Access Compliance Report

Public Rights-of-Way

(Curb Ramps)

Intersection ID: 10014572	Main Street: SCOTT_CREEK_DR	Cross Street: N/A	Location: NW
ADA ID: 43B598EFFCC7	Ramp Type: Perp	Initial Pass/Fail: Fail	Overall Compliance: No
Severity Score: 8.75			
Codes/Mitigation Info/Possible Solution		Field Measurements/Component Compliance

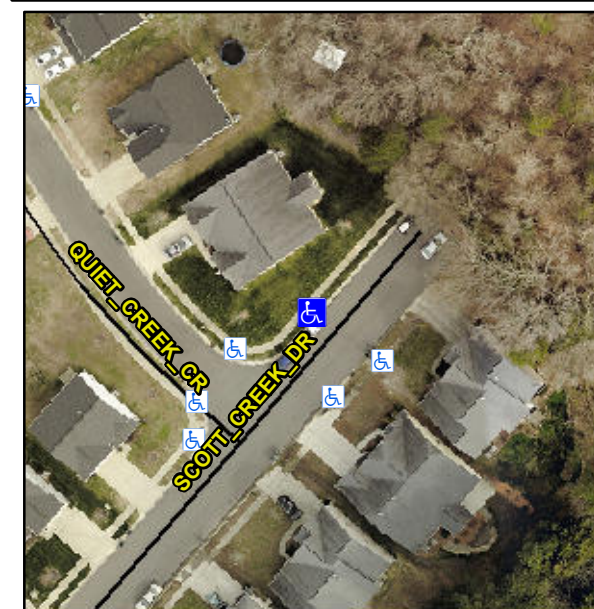
R304.5.1

Compliance	Description	Data	Compliance	Description	Data
N/A	Ramp Length (in)	46.0	Yes	Ramp Slope (%)	7.2
No	Ramp Width (in)	47.5	Yes	Ramp XSlope (%)	1.3
N/A	Flare Type LT	N/A	N/A	Flare Type RT	N/A
N/A	Flare Slope LT (%)	N/A	N/A	Flare Slope RT (%)	N/A
N/A	Flare Traversable LT?	N/A	N/A	Flare Traversable RT?	N/A
N/A	Landing Length (in)	N/A	N/A	DWS Provided?	N/A
N/A	Landing Width (in)	N/A	N/A	DWS Contrast?	N/A
N/A	Landing Slope (%)	N/A	N/A	DWS Length (in)	N/A
N/A	Landing X Slope (%)	N/A	N/A	DWS Full Width?	N/A
N/A	Landing Curb? (Y/N)	N/A	N/A	DWS Offset (in)	N/A
N/A	Shared Landing?	N/A			
N/A	Gutter Ponding?	N/A	N/A	Gutter Slope (%)	N/A
N/A	Gutter Lip Ht (in)	N/A	N/A	Gutter X Slope (%)	N/A
N/A	Painted X Walk1?	No	N/A	Painted X Walk2?	N/A
	X Walk 1 Direction	To SE		X Walk 2 Direction	N/A
N/A	X Walk 1 Width (in)	N/A	N/A	X Walk 2 Width (in)	N/A
	X Walk 1 Slope (%)	3.1		X Walk 2 Slope (%)	N/A
	X Walk 1 X Slope (%)	1.3		X Walk 2 X Slope (%)	N/A

Remove & Replace Entire Ramp.
